**STAFF REPORT TO THE BOARD OF ARCHITECTURAL REVIEW
PREPARED September 12, 2022**

FILE NUMBER: L22-0048

REQUESTS: Design Review approval for construction of a 121,156 square foot warehouse building with associated office space on an approximately 5.98-acre site along with associated site improvements.

LOCATION: 5910 S 180th Street, Tukwila, WA 98188
APN 3523049061

Figure 1. Proposed building footprint

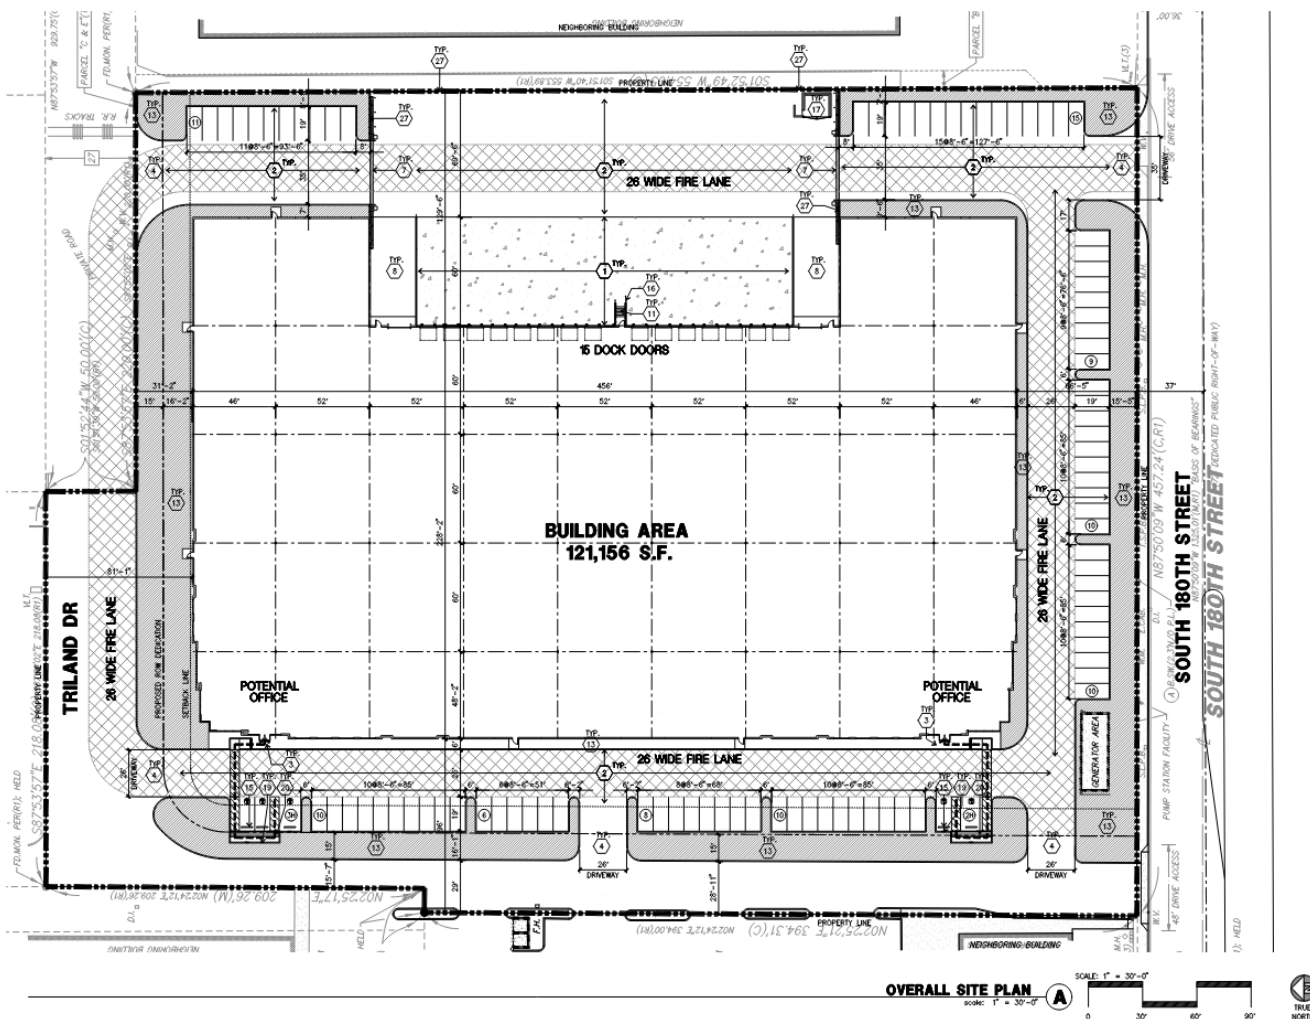
This project is to construct a 121,156 square foot warehouse building with associated office space on an approximately 5.98-acre site along with associated site improvements. The project will also establish new public streets at unimproved portions of Triland Drive and an unnamed Workplace Corridor on the west side of the parcel.

Figure 3. Corridor Map. Approximate site shown with orange star.

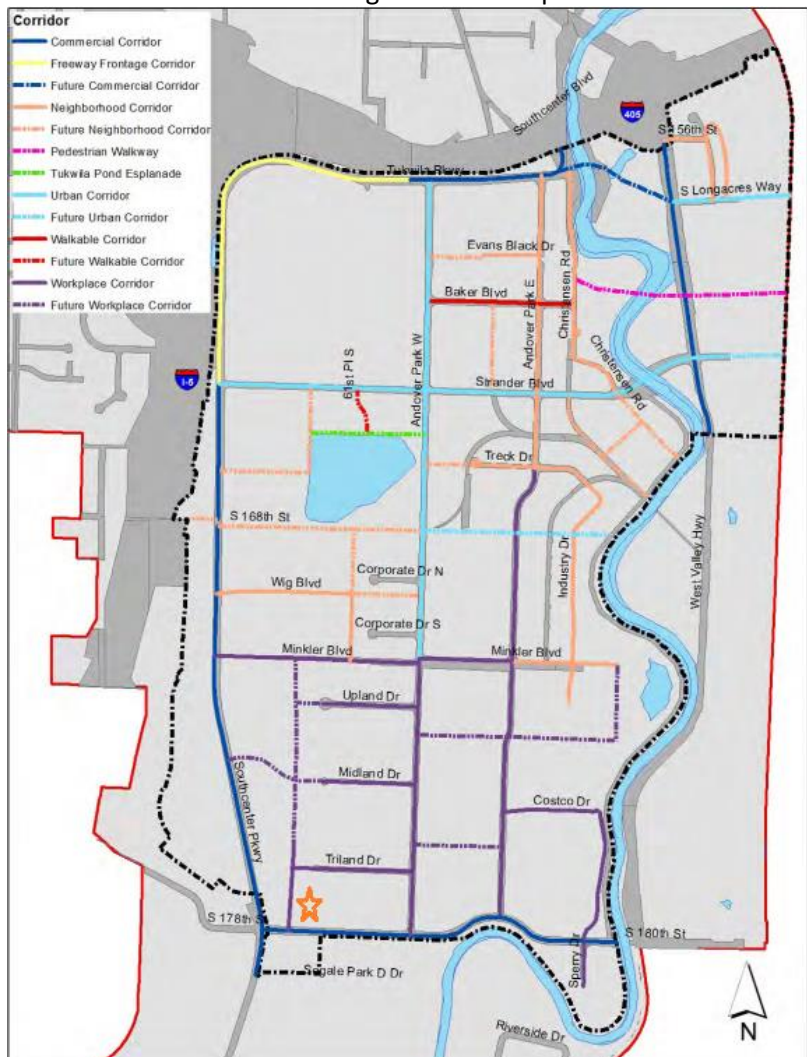
As shown in figure 3, Triland Drive and the unnamed access road on the west portion of the property are both considered Workplace Corridors. South 180th Street is considered a Commercial Corridor. See attachment D for the Corridor Standards sheets.
